**From:** [Mark Benjamin](#)  
**To:** [Bradley Peens](#)  
**Cc:** [Aoife Mac Sharry](#)  
**Subject:** RE: BUN60427502 - 538 K Road - revised design information and specialist reports  
**Date:** Thursday, 8 August 2024 9:49:58 am  
**Attachments:** [image005.png](#)  
[image007.png](#)  
[image008.png](#)  
[image009.png](#)  
[image010.png](#)  
[image011.png](#)  
[image012.png](#)  
[image013.png](#)  
[image014.png](#)  
[image015.png](#)  
[image016.png](#)  
[image018.png](#)  
[image019.png](#)  
**Importance:** High

## RESPONSE TO EMAIL OF 1<sup>st</sup> AUGUST

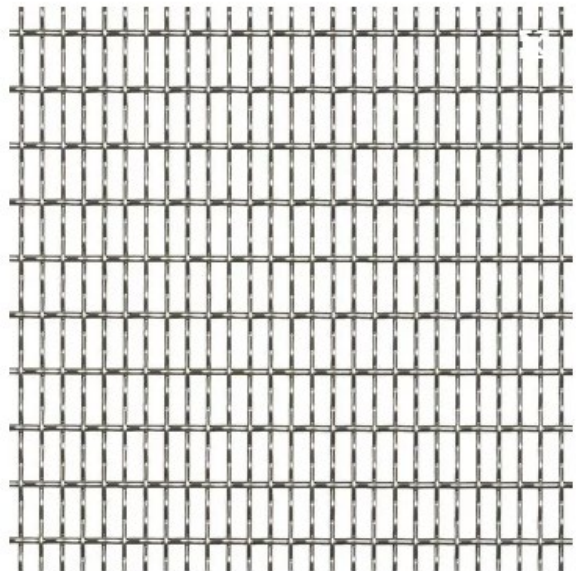
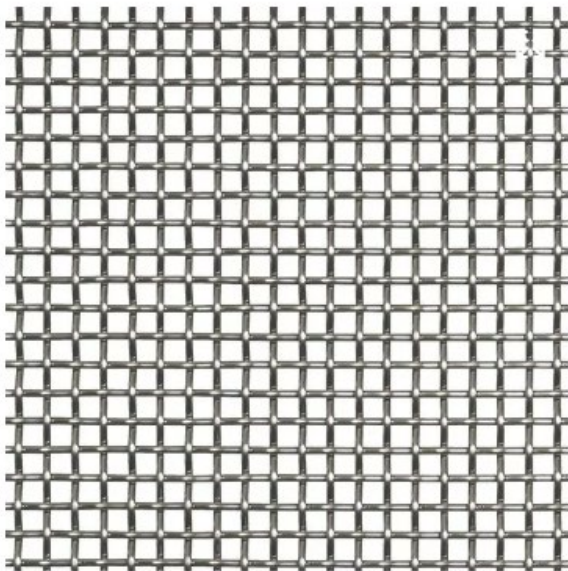
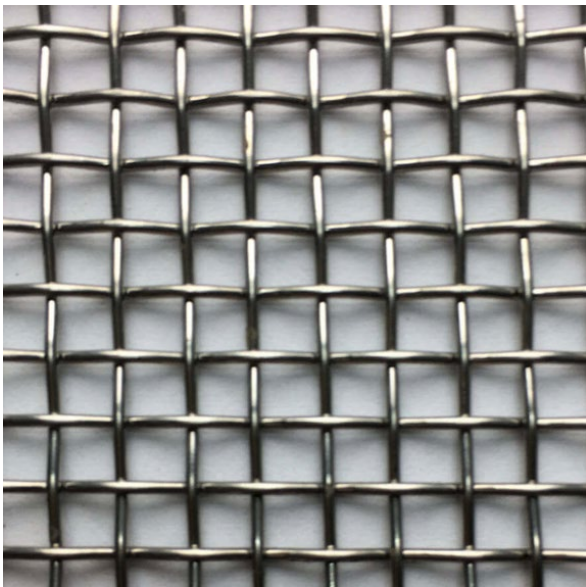
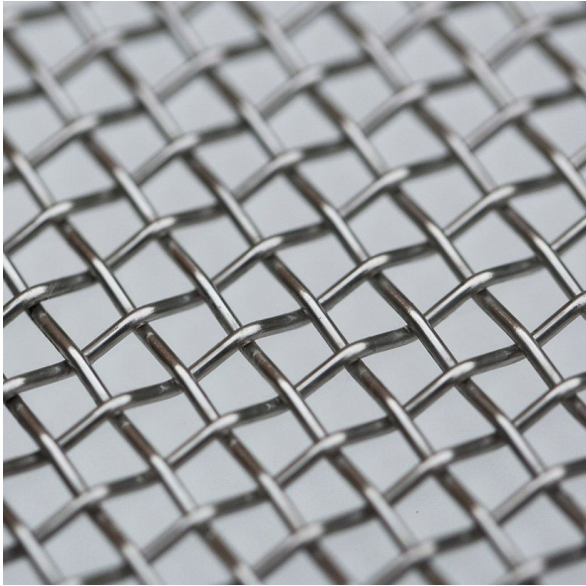
I have a few queries regarding the perforated screen for the external stair.

- Is this intended to be standard perforation (circular?) or a pattern, image, or varied colour proposed?

At this stage, the screen enclosure would be an open wire mesh, approx.. 20mm aperture / openings. (rather than metal sheet perforations)

A standard wire / woven mesh image has a square-like or rectilinear profile, see below.

Mesh visibility / permeability.

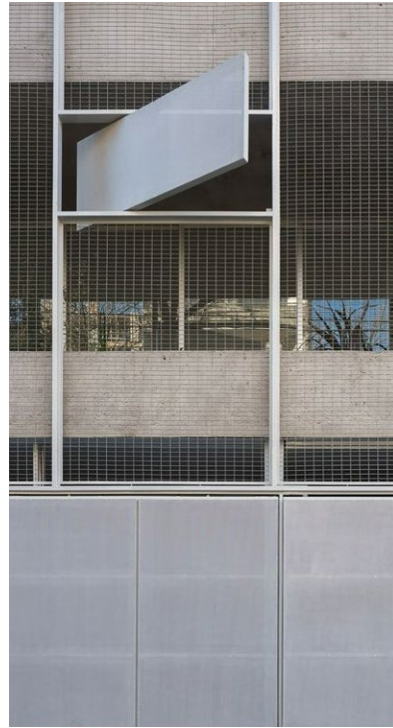
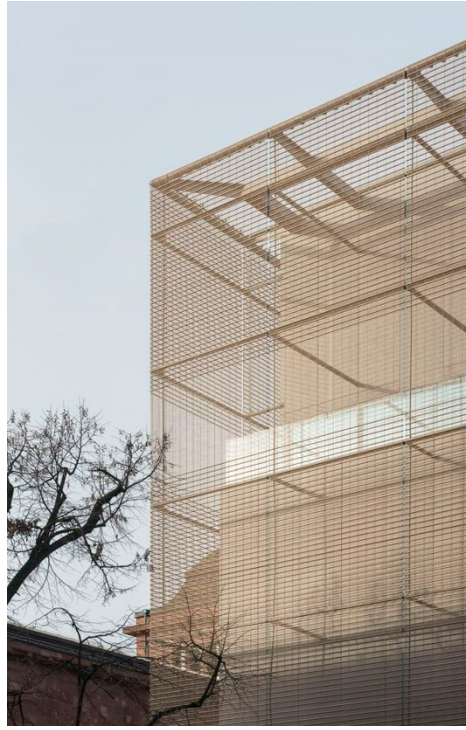
- What is the level of visual permeability vs solidity proposed noting the surrounding area of glass, and providing variation/relief.

As per the images below, with an approx.. 20mm aperture (including openness for wind flow), there will be a high level of permeability across the entire zone of screening which will allow readability of the stair structure and massing elements behind, providing variation and relief.

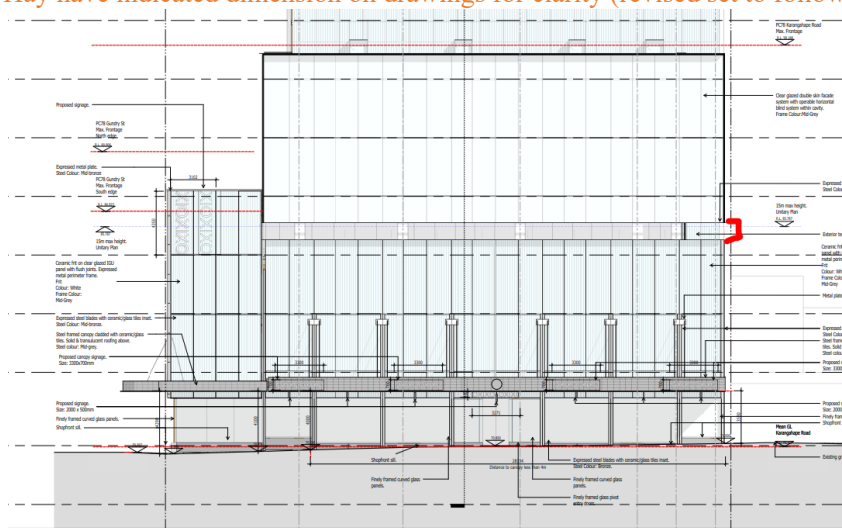
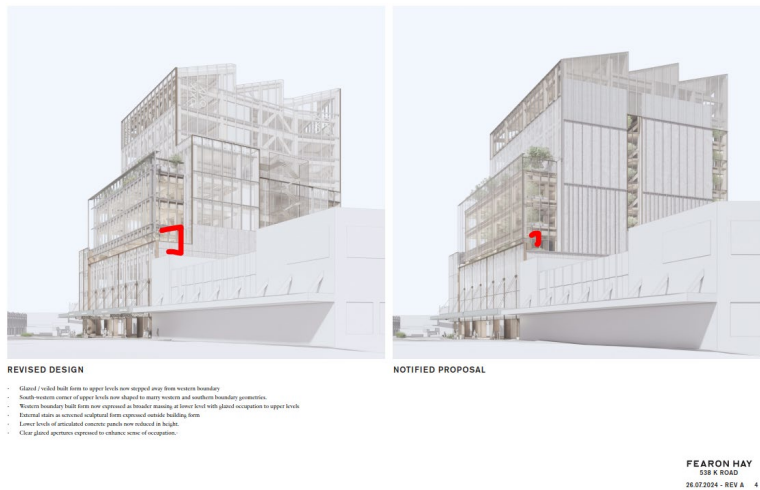
Could the applicant provide a dimension for the 'gap' below. While the comments note that the northern elevation is generally the same, the renders suggest potentially greater gap is achieved between the floors - or perhaps this is just representing the changes to the western elevation?

The gap height is now 800mm (previously was 500mm).

During developed design, we revised the heights for these two datum lines to respond to compliance, use of terrace / balcony, and visual outlook (ie, raising the underside of the wintergarden glazing level to allow unencumbered views out).

Fearon Hay have indicated dimension on drawings for clarity (revised set to follow).

FEARON HAY  
538 K. ROAD  
26.02.2024 - REV A 4

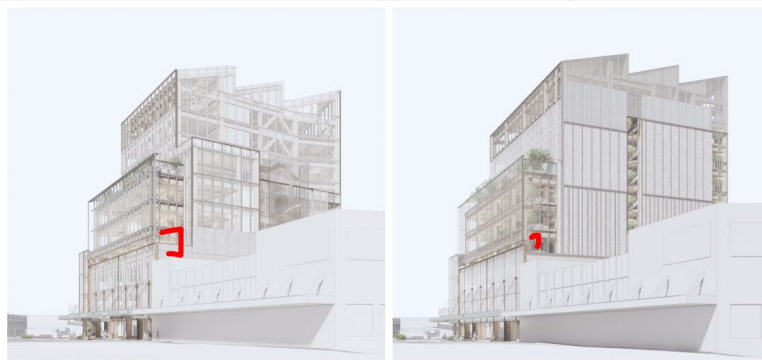
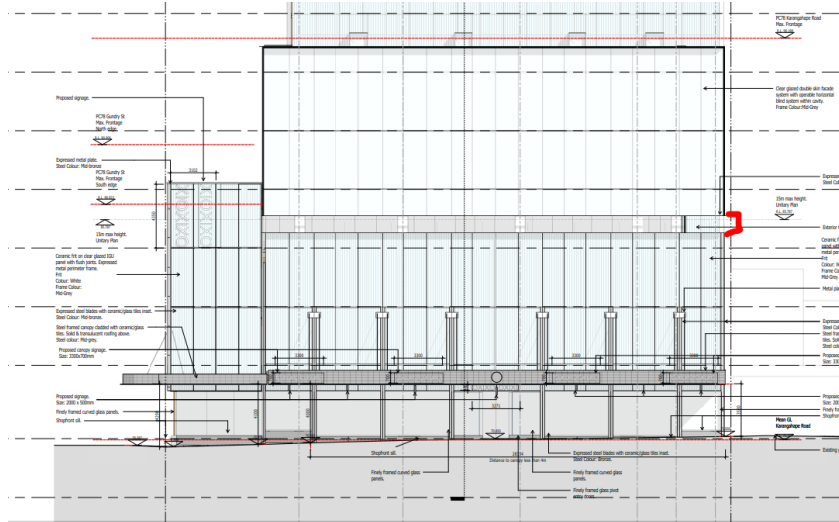
I have a few queries regarding the perforated screen for the external stair.

- Is this intended to be standard perforation (circular?) or a pattern, image, or varied colour proposed?
- What is the level of visual permeability vs solidity proposed noting the surrounding area of glass, and providing variation/relief.
- Is it intended to be lit at night?

Could the applicant provide a dimension for the 'gap' below. While the comments note that the northern elevation is generally the same, the renders suggest potentially greater gap is achieved between the floors - or perhaps this is just representing the changes to the western elevation?
